# SOUTHERN ENVIRONMENTAL LAW CENTER

**Re: Proposed Corrective Action Plan for the Plantation Pipeline Lewis Drive  
Release - Site # 18693**

The Southern Environmental Law Center submits these comments on the proposed Corrective Action Plan for the Lewis Drive release site on behalf of Upstate Forever and Savannah Riverkeeper.

# ATTACHMENT 1

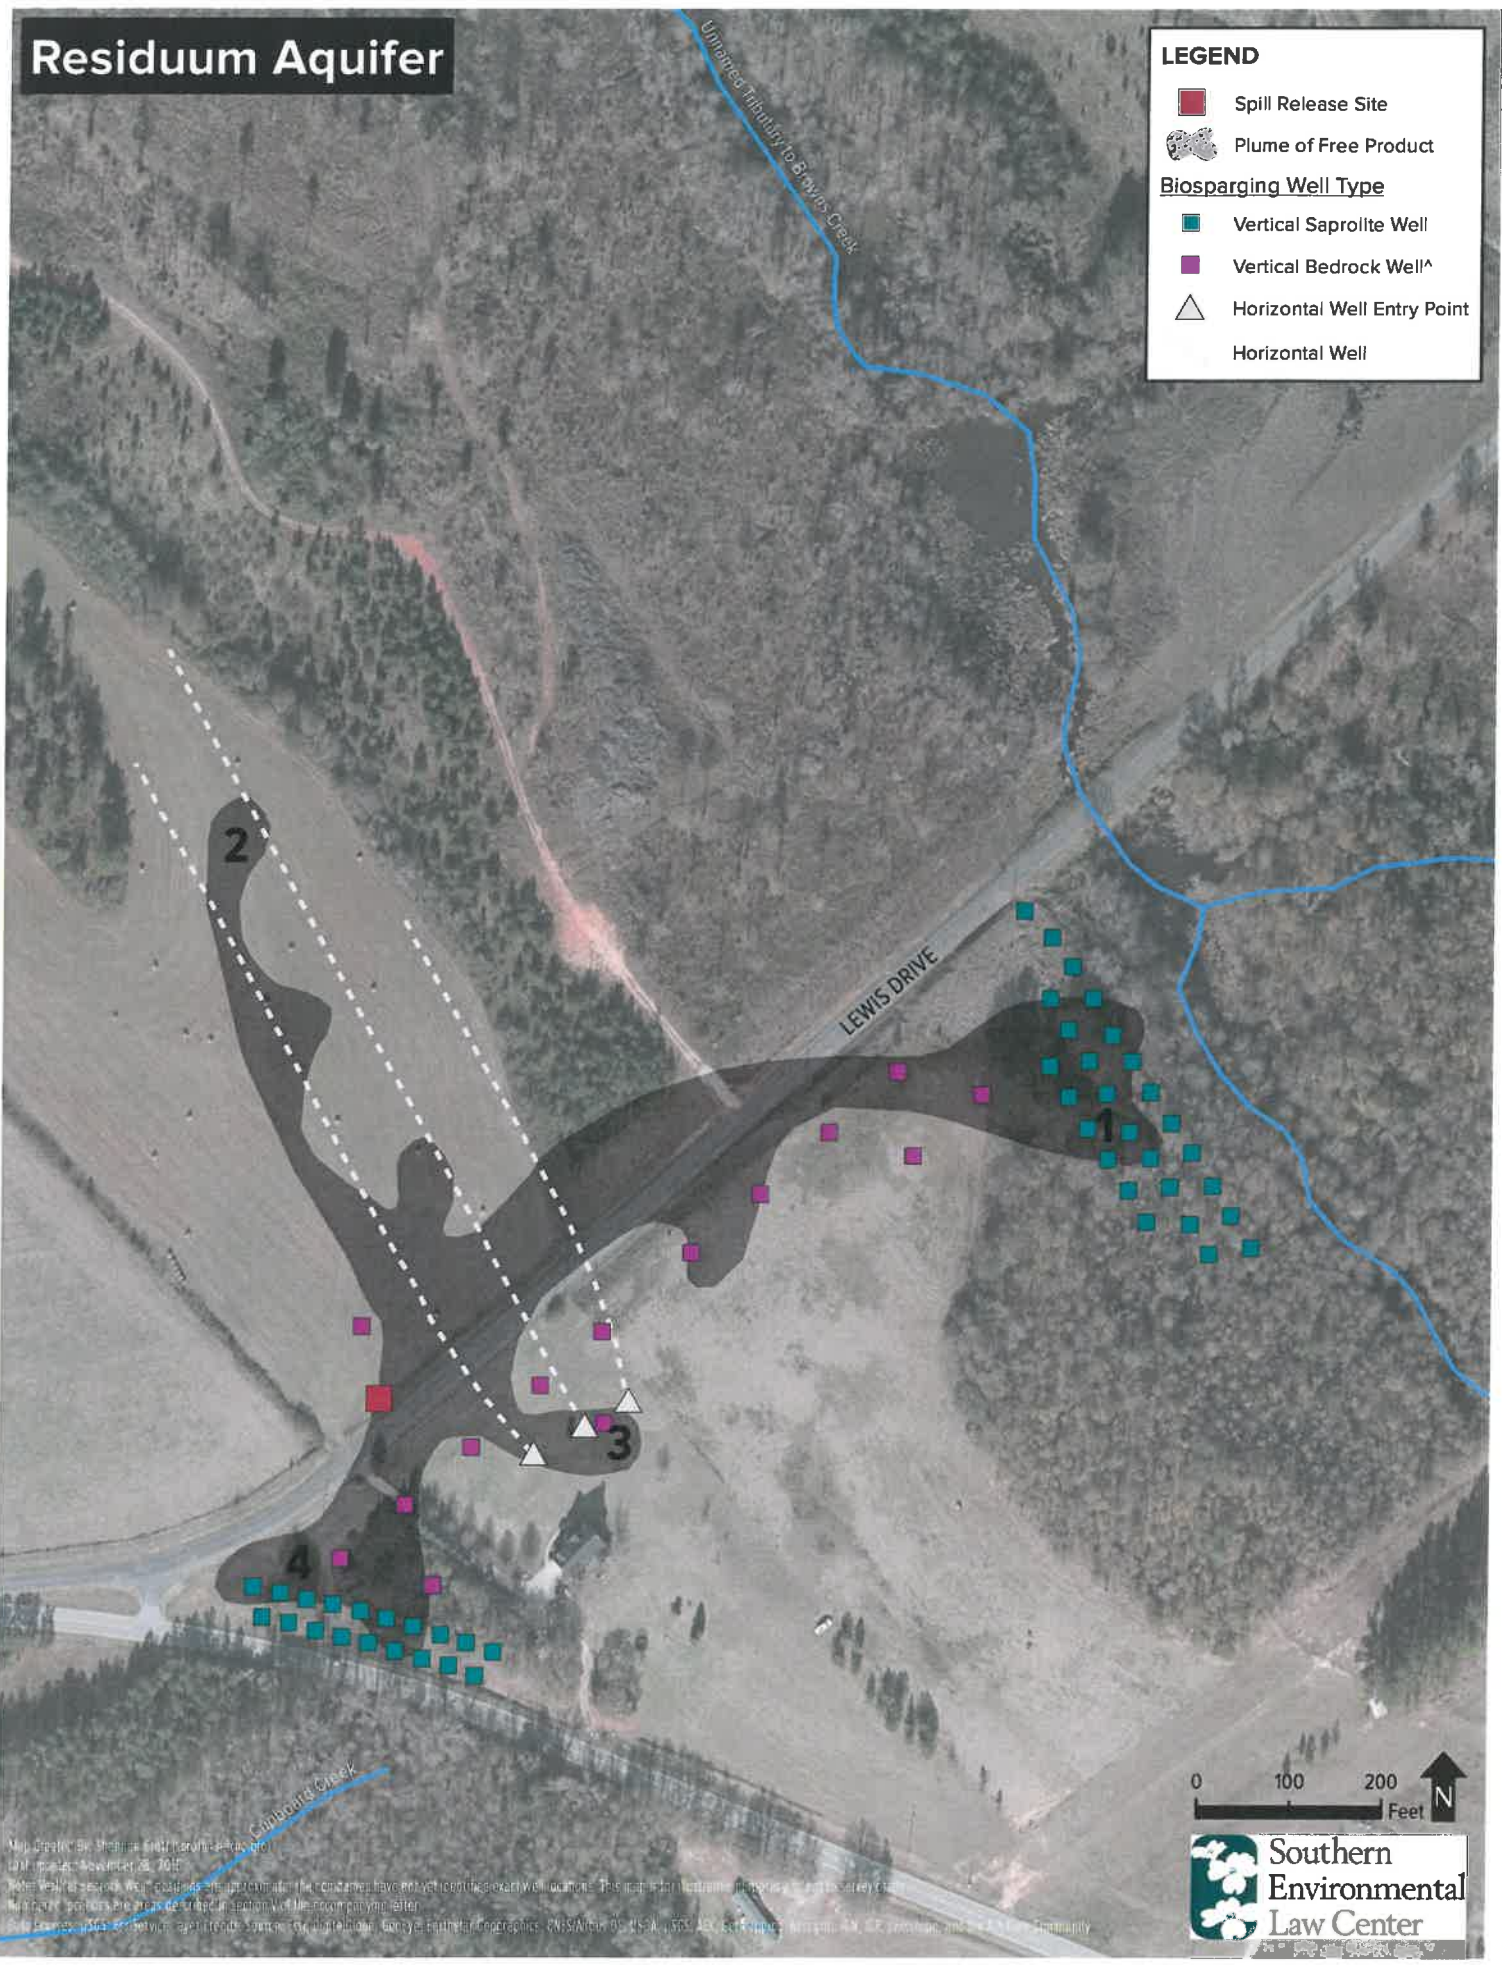
The companies’ consultants have defined a plume of free product in the overlying residuum and in the bedrock aquifer,<sup>19</sup> but have not proposed biosparging in several portions of the plume. Figure 7 of the CAP shows product extending in the overlying residuum in four directions: 1) about 1,000 feet to the east-northeast from the spill site along and south of Lewis Drive toward the Browns Creek tributary, 2) about 1,000 feet to the north-northwest into the hayfield zone, 3) about 300 feet to the east, adjacent to a former residence, and 4) about 300 feet to the south-southwest toward Calhoun Road and Cupboard Creek. These areas are identified in the map included as Attachment 1.

Additional biosparging should occur in each of these areas. Only the second area in the hayfield zone is currently addressed in the CAP. The horizontal well biosparging solution

proposed in that area may be effective in breaking-down constituents to the north, but a final array of intercept biosparging wells should also be deployed at the northern end of this plume, between the current monitoring wells MW-30 and MW33T. This array is necessary to prevent contaminants from continuing to release to the north and northeast. The plumes extending east-northeast toward the Browns Creek tributary and south-southwest toward Cupboard Creek (areas 1 and 4) are not addressed until the biosparging arrays at the distal ends of the plume in the surface water protection zone. Additional wells should be installed in the center of these portions of the plume, especially along Lewis Drive. In addition, given the trajectory of these portions of the plume, the arrays in the surface water protection zone should be extended so that they are also on the north side of Lewis Drive along the Browns Creek tributary, and on the other side of Lewis Drive from Cupboard Creek toward MW-36. The portion of the plume extending east toward the former residence (area 3) is not addressed at all. Vertical or horizontal biosparging wells should be installed in that area.

## ATTACHMENT 2

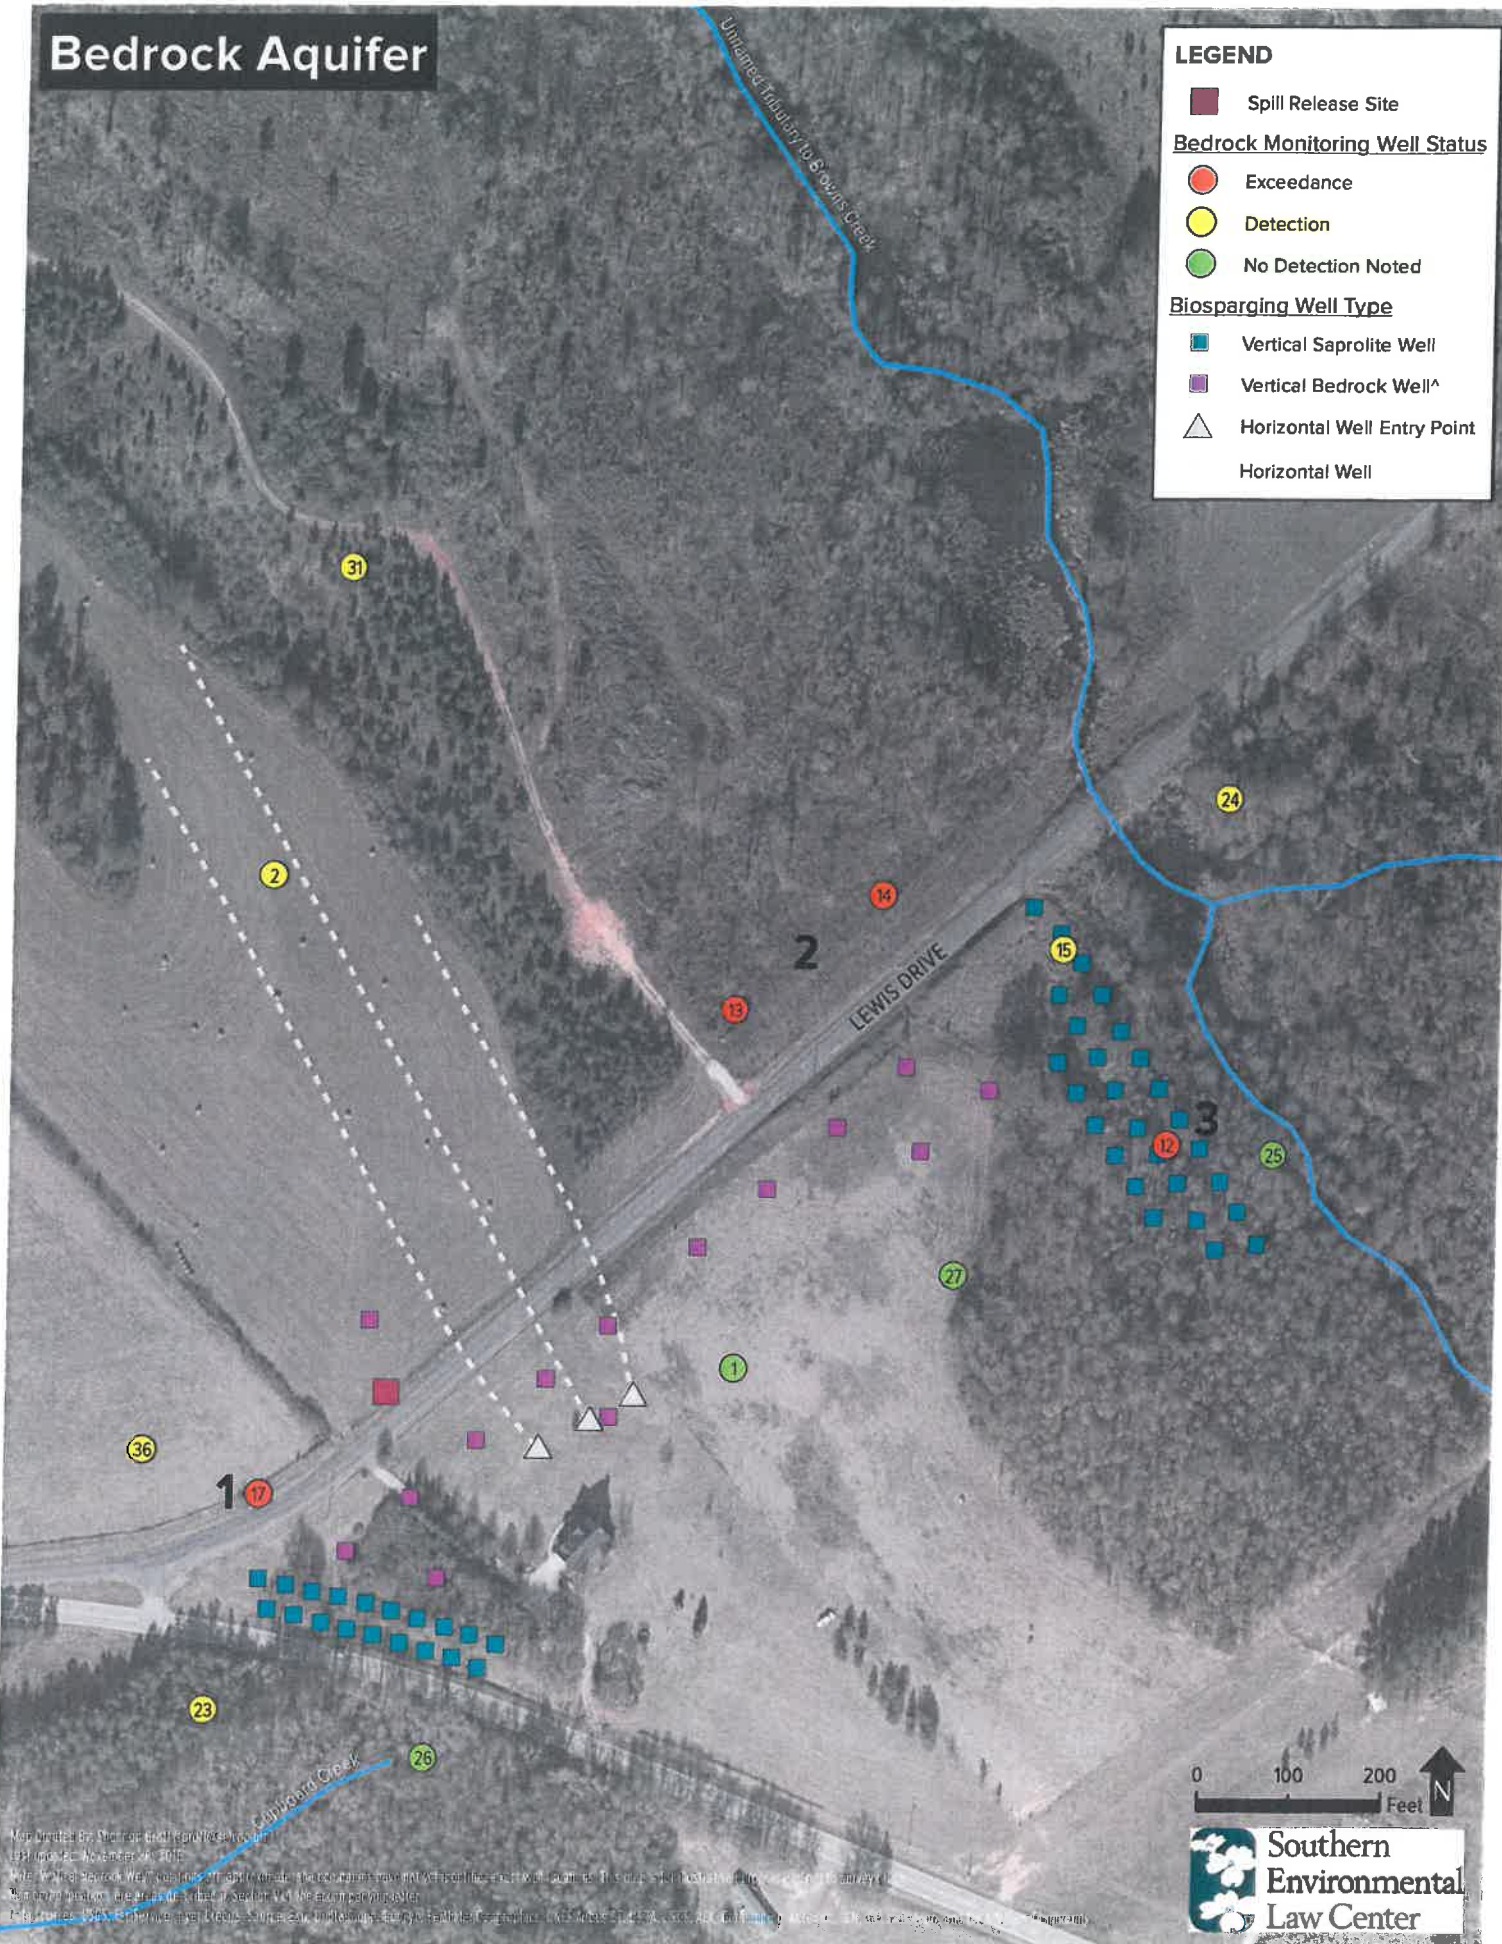
In the bedrock aquifer, the companies' consultants have reported contamination detections or exceedances of state and EPA standards in ten different bedrock monitoring wells.<sup>20</sup> Looking at the wells that recorded exceedances, free product in the fractured bedrock aquifer appears to extend in at least three directions: 1) about 200 feet in the southwest direction, north of Lewis Drive (MW-17B), 2) about 600 to 800 feet in the northeast direction, north of Lewis Drive (MW-13B and MW-14B), and 3) about 1,000 feet in the east-northeast direction, south of Lewis Drive and along the tributary of Browns Creek (MW-12B). These areas are identified in the map in Attachment 2. None of these areas are addressed in the CAP, as the proposed bedrock biosparging wells will be closer to the spill than any of these bedrock monitoring wells. The proposed wells are also currently very ill-defined—the CAP only states that thirteen biosparging wells will be installed at locations to be determined based on results from three initial wells somewhere below Lewis Drive. Furthermore, bedrock biosparging is not proposed at all in the area above Lewis Drive and toward Cupboard Creek (area 1). The CAP must also be revised to address area 2, both through bedrock biosparging wells and through an extension of the biosparging array in the surface water protection zone to the north side of Lewis Drive where the bedrock aquifer discharges to the Browns Creek tributary.
